CONNECTION ASSESSMENT & APPROVAL PROCESS

PRELIMINARY ASSESSMENT REPORT

APPLICANT: Kitchener-Wilmot Hydro Inc.

PROJECT: Proposed New 230-14.2 kV Transformer Station

FIGURE 1

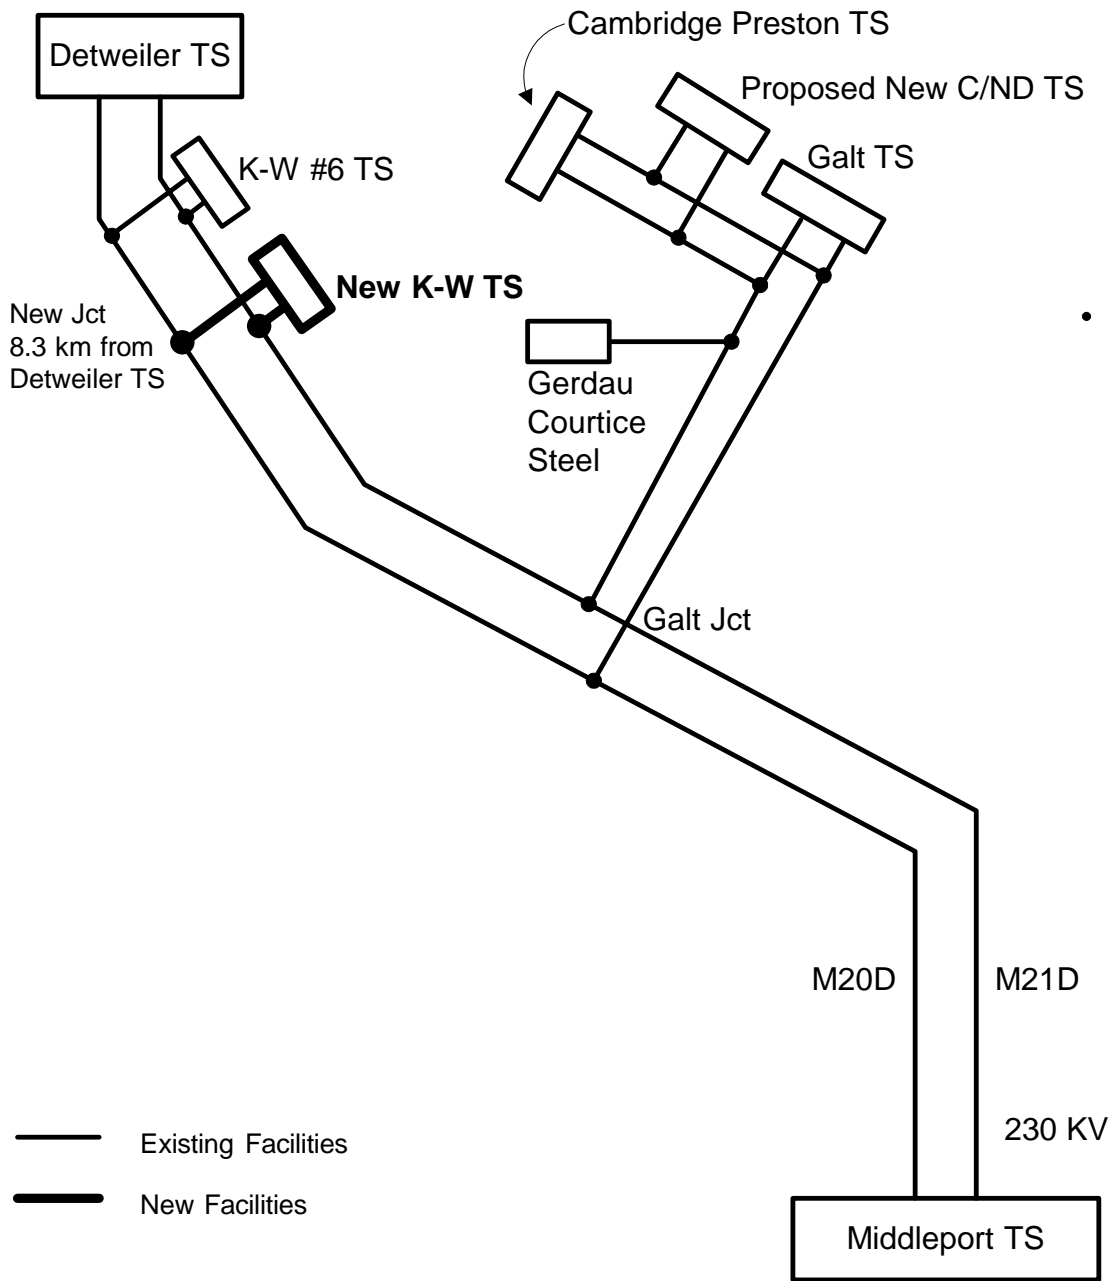
The proposed new TS will be supplied at 230 kV via the existing Hydro One Detweiler TS x Middleport TS 230 kV circuits M20D and M21D, as shown in Figure 1. These circuits also supply Galt TS, Cambridge Preston TS, Gerdau Courtice Steel and the proposed new C/ND TS.

FIGURE 2
Detweiler TS 230kV Voltage Measured in Year 2000

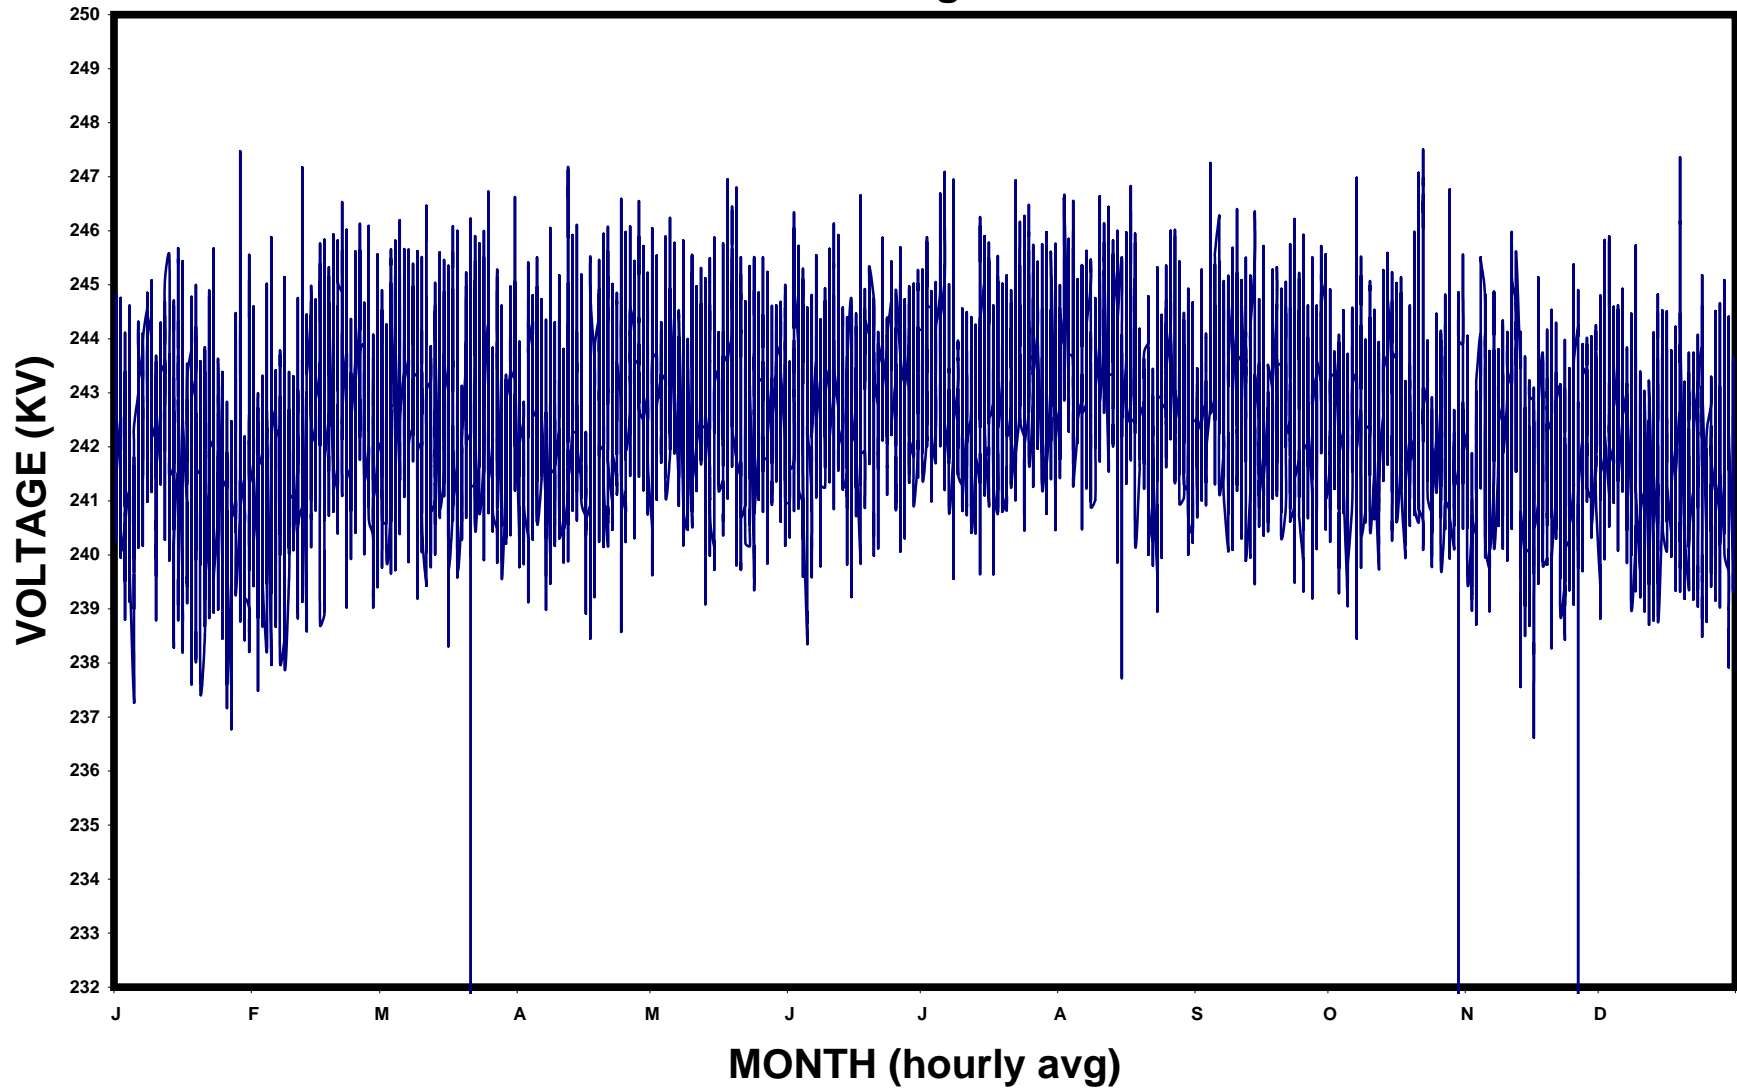
Figure 2 shows the actual measured voltage at Detweiler TS 230 kV bus during the year 2000. The voltage at the location of the proposed new K-W TS is expected to be approximately 0.5 kV below the level at Detweiler TS. Future voltage levels may vary depending on load and system developments.
